ATTACHMENT 1
PUBLIC COMMENT LETTERS

From: [Richard Block](#)
To: [Eguez, Judy](#)
Cc: [Norton, Brian](#); [Leonard Nunney](#); [Gurumantra](#); [Kevin Dawson](#); [clearspan@aol.com](#); [Tinio, Maribeth](#); [Taylor, Matthew](#)
Subject: RE: [External] FW: Mt Vernon Ave RC zone site proposalPR-2021-001108(DR, GE), APN 257-160-003
Date: Friday, February 10, 2023 4:45:51 PM
Attachments: [8500E500725F4D7082C06036BC0DD61D.png](#)
[image001.png](#)
[image002.png](#)
[image003.png](#)

Re: LANDEROS RESIDENCE – APN: 257-160-003 – PLANNING
CASE P20-0427 (PLOT PLAN REVIEW)

Image 1 Typical Off Shore

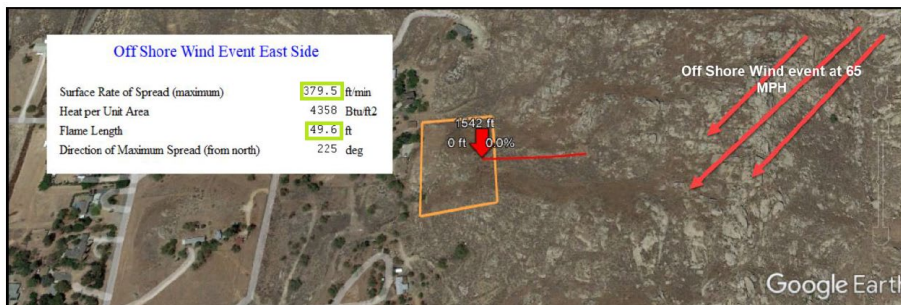
See fire simulation below, 379.5 rate of fire spread on the top of the hill versus 399.5 rate of fire spread. Flame length at the top of the hill 49.6 ' versus 50.8 ' at the North side

Mr. Block's statements are baseless and false. The FPP prepared by a licensed fire engineer shows the conditions at the bottom of the hill have increased fire risk. A "worse case" fire scenario computer simulated for the north side of the hill (location recommended by Mr. Richard Block) and the typical offshore (current proposed location) show the north has higher fire risk. The simulation shows the north side burns at a faster speed and with longer flames than the current proposed location.

As stated previously, per the fire consultant, and the city fire department, the pad cannot be located at the bottom section of the property. No adequate fire protection plan can be created with the house located at the bottom of the hill because of lack of defensible space. **In summary, building at the bottom of the hill has a higher fire risk than building at the top of the hill.**

Figure 1: Transition Grading (Cut and Fill)

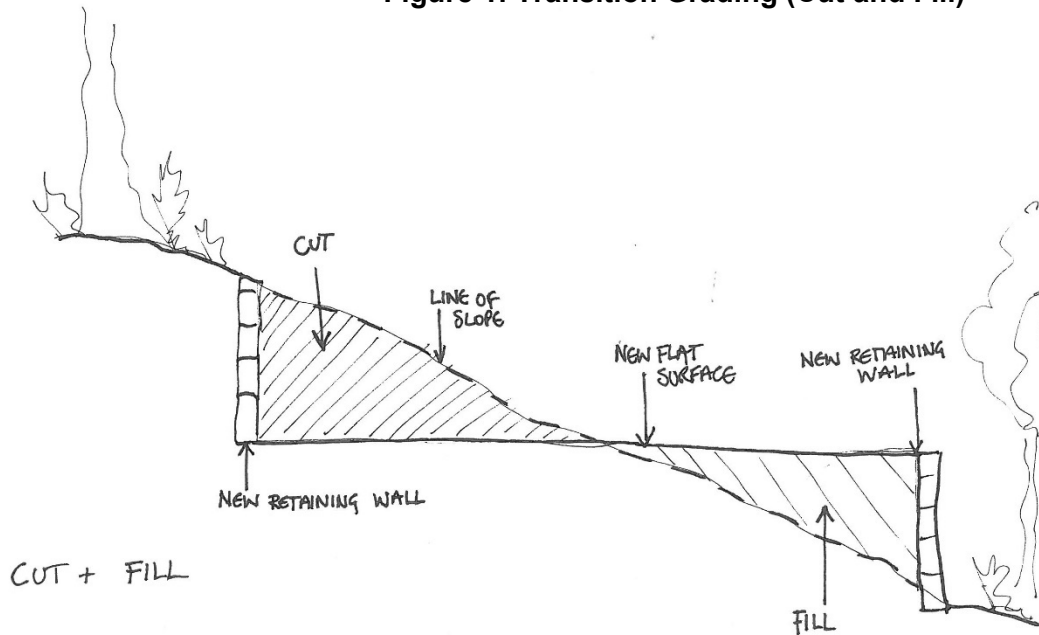
If the pad is placed at lower portion of the site, this creates a transition grading situation which requires cut and fill (see Figure 1). Typically, the building requires 3' to 5' overexcavation over the existing surface and recompacted to 90% relative compaction. The amount of grading is excessive. Alternatively, stepped building layout typically used to avoid excessive cut and fill (see Figure 2). However, the stepped building layout requires shoring walls and extensive amount of retaining wall which creates a financial burden to the owner. Therefore, in our opinion, the proposed pad location fits into the natural terrain and most economical to the owner.

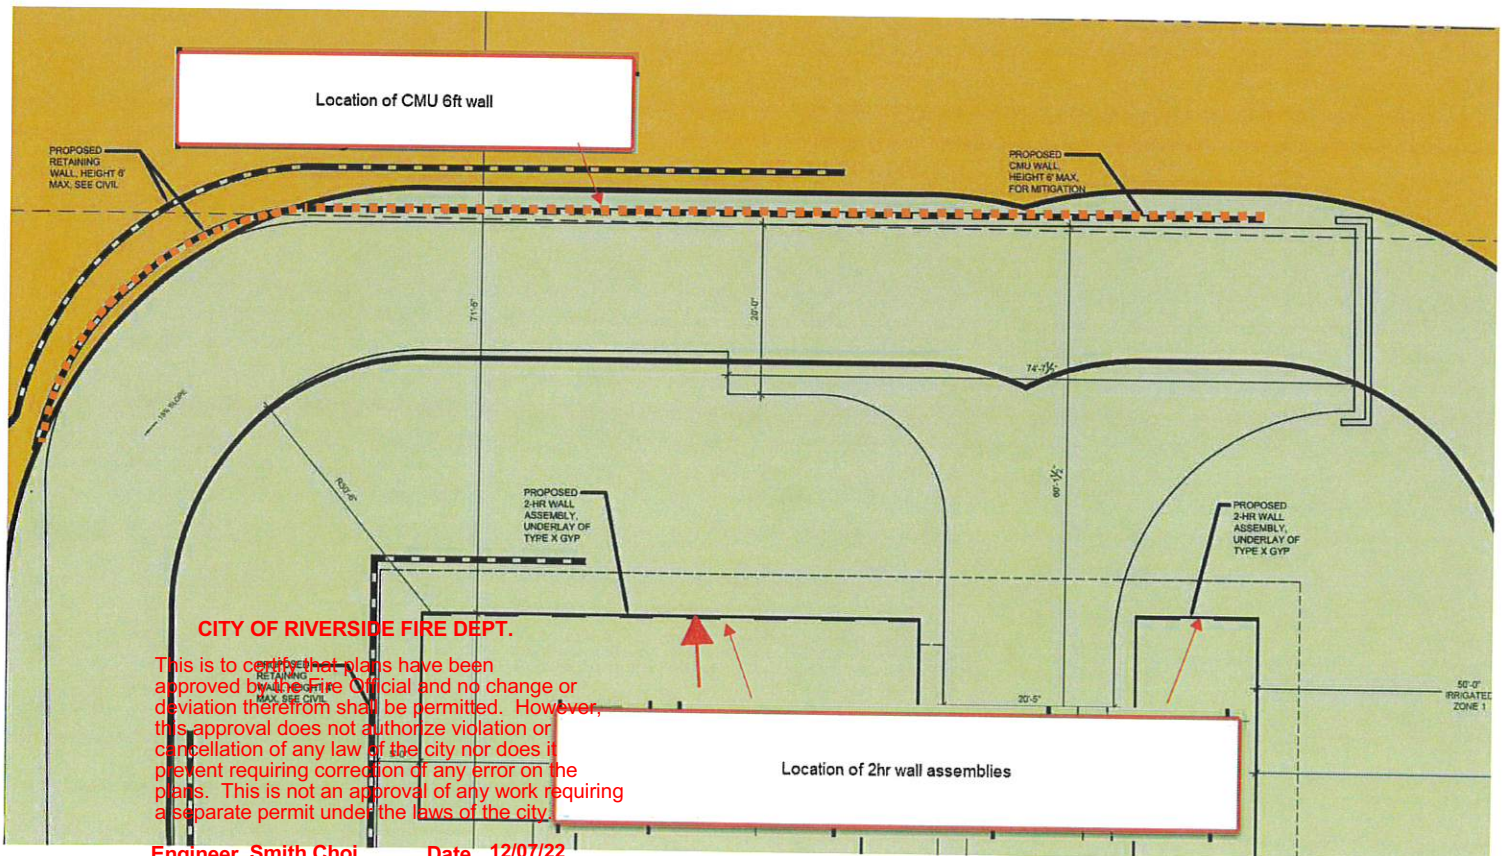
We are proposing a 6' tall CMU wall/barrier on the north side of the parcel as designated on the exhibit. AND a 2-hour rated exterior wall surfaces of the SFR and ADU with walls facing the exposed open area with reduced separation.

1) The proposed wall has generally been accepted as an alternate mitigation measure when projects have less than a 100-foot buffer as it provides a barrier for radiant heat at the leading edge of a fire and reduces/stops wind-blown ground embers. The heat flux at the barrier is only momentary. In this case the flame lengths are less than the distance to the structure envelope. See attached additional information on site wall design and site images for locations.

2) In conjunction with the added site fire walls, the exterior wall surface of the homes facing reduced buffered areas will be built with 2-hour fire rated surfaces at the vertical walls on the exterior fire exposed sides (exempt of windows and door which will comply with typical fire zone requirements of the WUI). See attached additional information on the tested 2-hour wall design "GA FILE NO. WP 8207" comprised on 2 layers of 5/8" type X gypsum wall board behind the exterior finish and site images for locations.
